<b>Docket Number:</b>	08-AFC-07C
<b>Project Title:</b>	GWF Tracy (Compliance)
<b>TN #:</b>	202440
<b>Document Title:</b>	Request for Approval of Proposed Project Minor Modification
<b>Description:</b>	N/A
<b>Filer:</b>	Paul Kihm
<b>Organization:</b>	Latham & Watkins LLP
<b>Submitter Role:</b>	Applicant Representative
<b>Submission Date:</b>	6/9/2014 3:13:04 PM
<b>Docketed Date:</b>	6/9/2014

IN THE MATTER OF: ) DOCKET NO. 08-AFC-07C  
)  
GWF Tracy Combined Cycle Power Plant ) REQUEST FOR APPROVAL OF  
) PROPOSED PROJECT MINOR  
) MODIFICATION  
)  
\_\_\_\_\_ )

**GWF ENERGY LLC**  
GWF TRACT COMBINED CYCLE POWER PLANT  
TRACY, CALIFORNIA

**SITE PLAN**

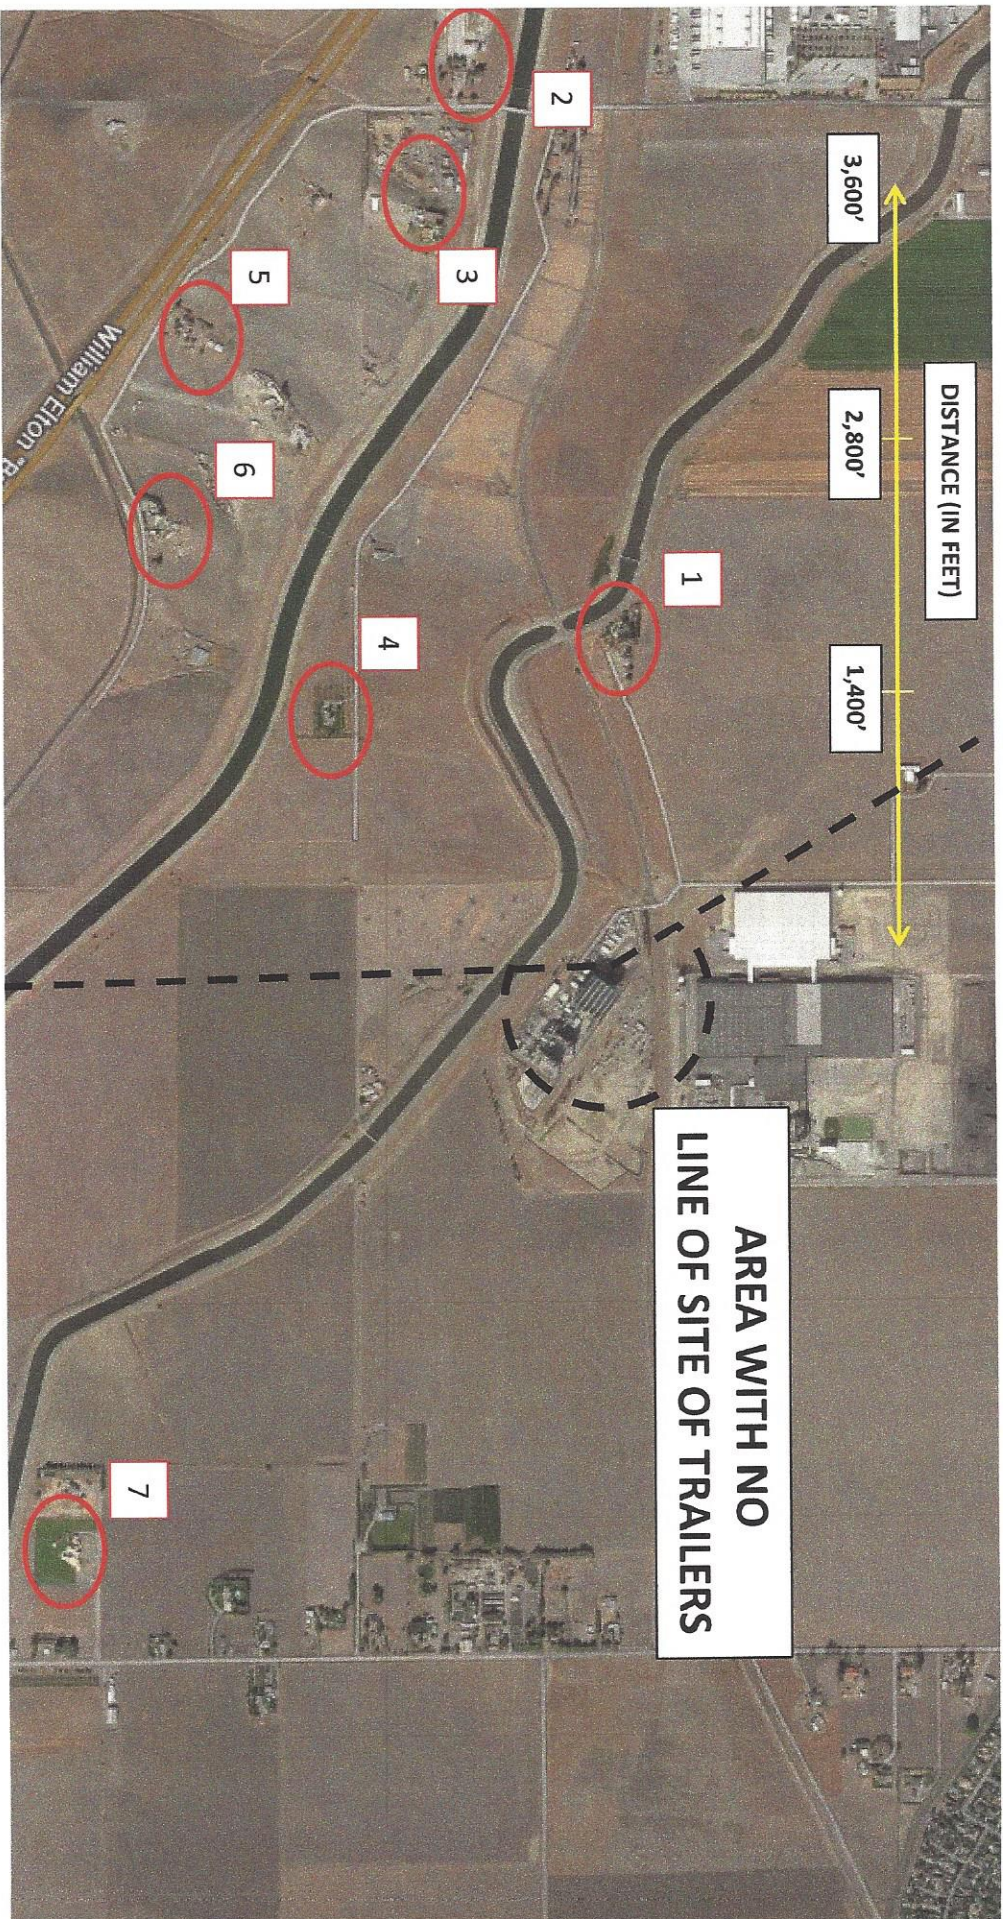
First, GWF requests is that the existing trailers remain on site permanently. The existing trailers are a single wide (16’ x 90’) trailer and a double wide (24’ x 90’) trailer. Second, GWF requests permission to install an additional single wide trailer adjacent to the existing double wide trailer.

Attachment 2 includes a site map with a mark-up showing the existing trailers and the proposed new trailer. No conditions will be affected by this change.

# View from 1

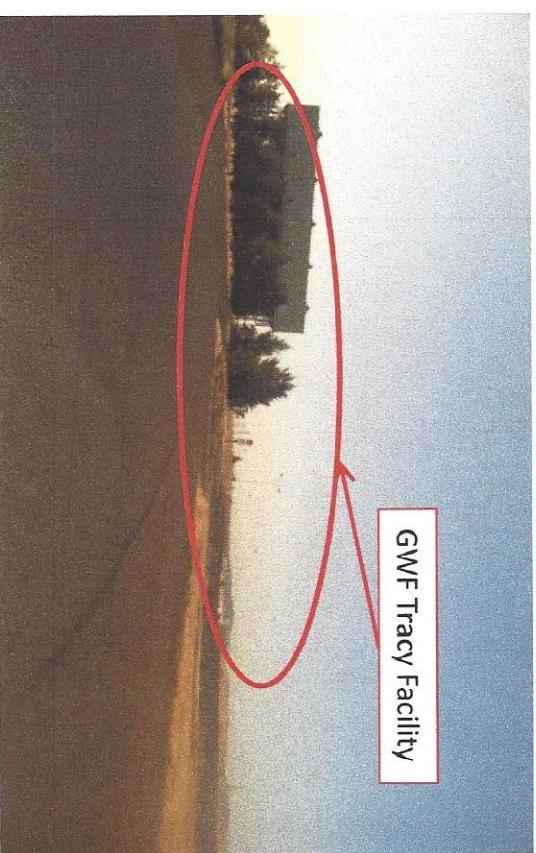
- Description: No line of site to trailers, fence-line completely blocks view

## View from 2

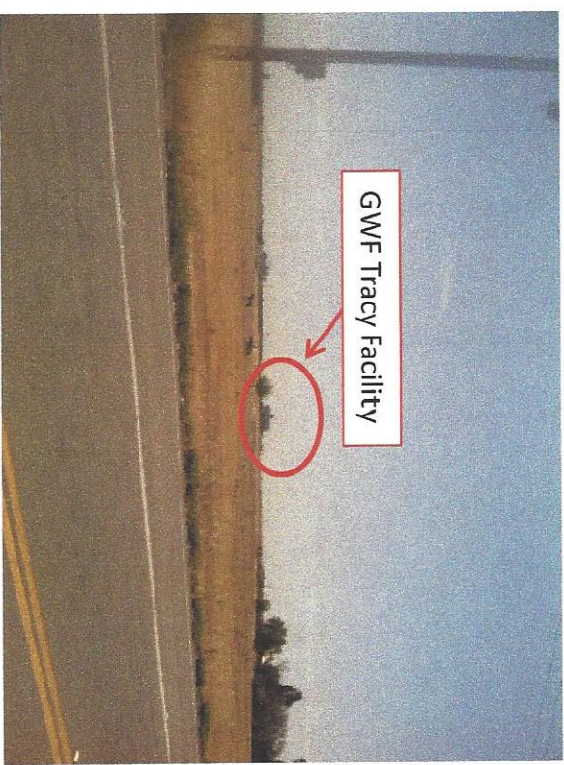
- Description: No line of site to trailers, fence-line completely blocks view

# View from 3

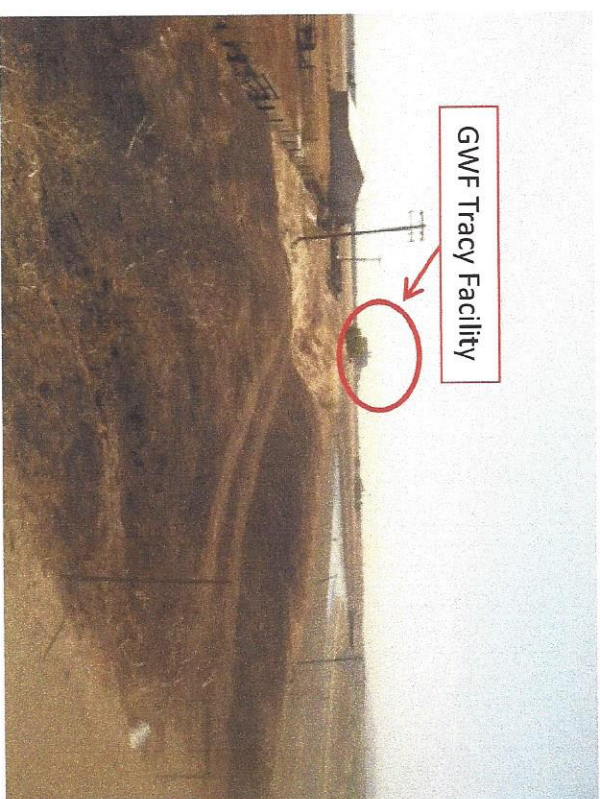
- Description: No line of site to trailers.

# View from 4

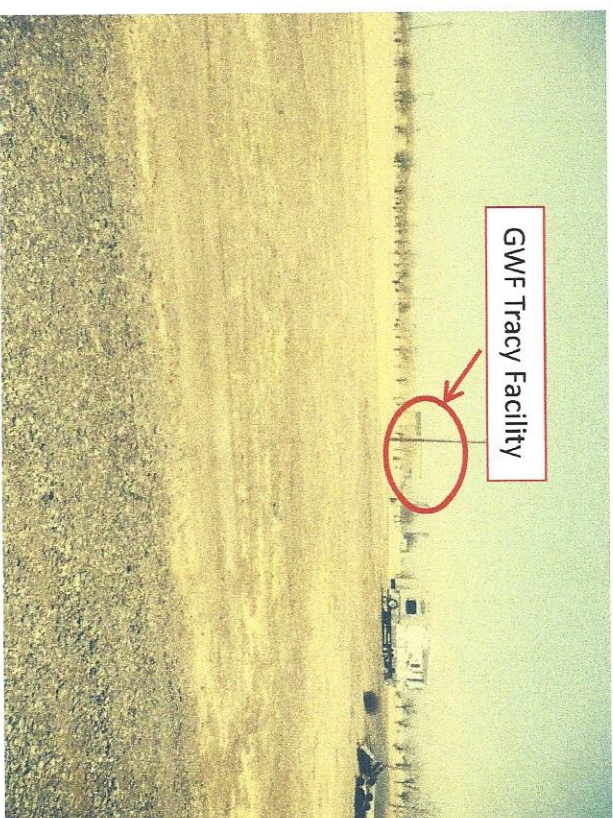
- Description: No line of site to trailers.

# View from 5

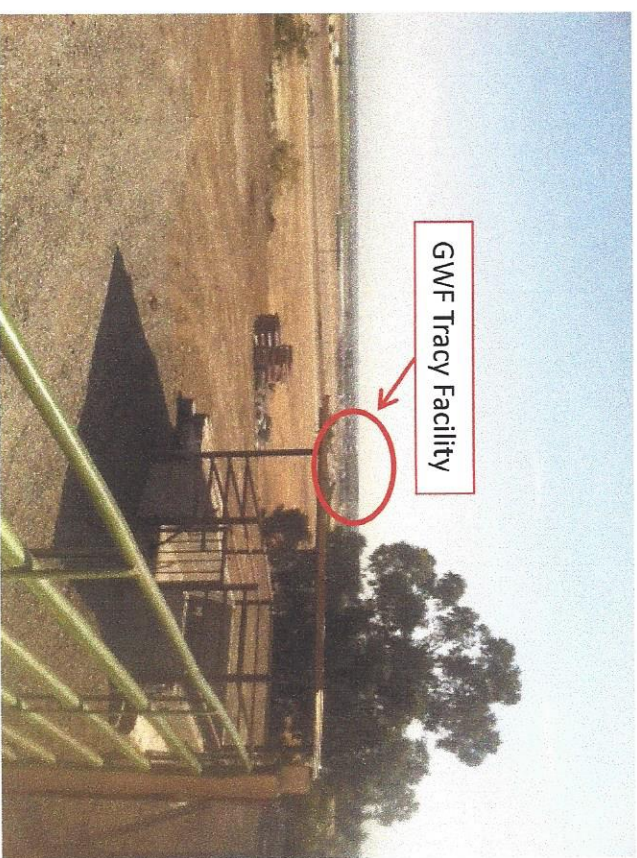
- Description: Tracy Trailers not visible with naked eye

# View from 6

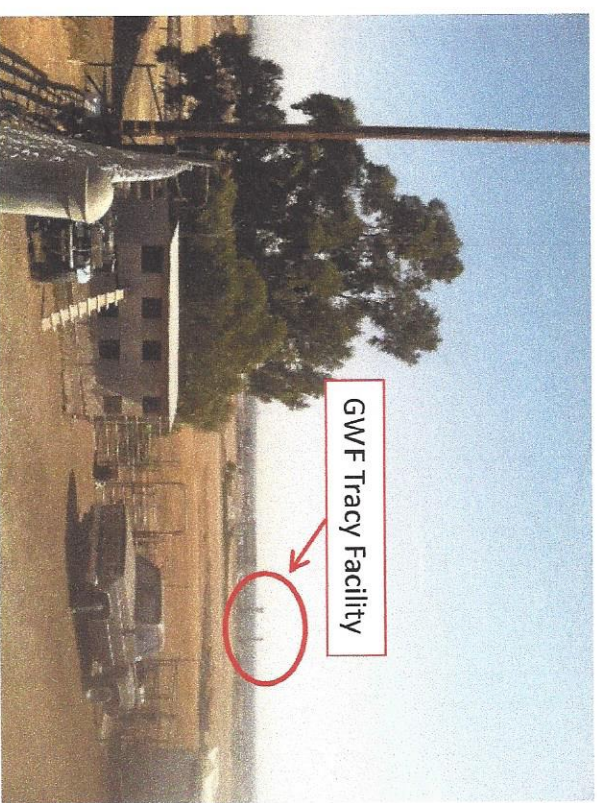
- Description: Tracy Trailers not visible with naked eye.
